**Town of China Planning Board Decision
On Conditional Use Permit CU-2017-07**

Applicant: Kennebec Community Church
Date: December 12, 2017
Location : 627 Route 3
Map 22
Lot 119A

Stormwater Treatment (#1,2,& 3)
Kennebec Community Church
M22 L119A

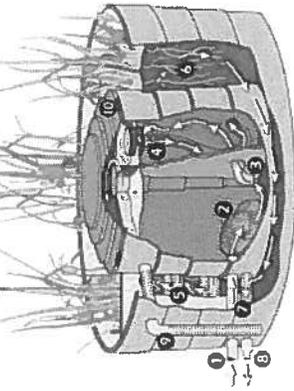
Ms. Austin questioned whether the clearing proposed toward the road would interfere with the use of this buffer to address the Phosphorus Control Ordinance. CEO Mitnik agreed to provide evidence at the next meeting to assure that other phosphorus controls provided as a part of DEP's stormwater permit would be adequate.

Vote 4-0 with a condition on the permit for CEO Mitnik to check that the reduction of vegetation in the roadside buffer would not compromise the needed phosphorus controls.
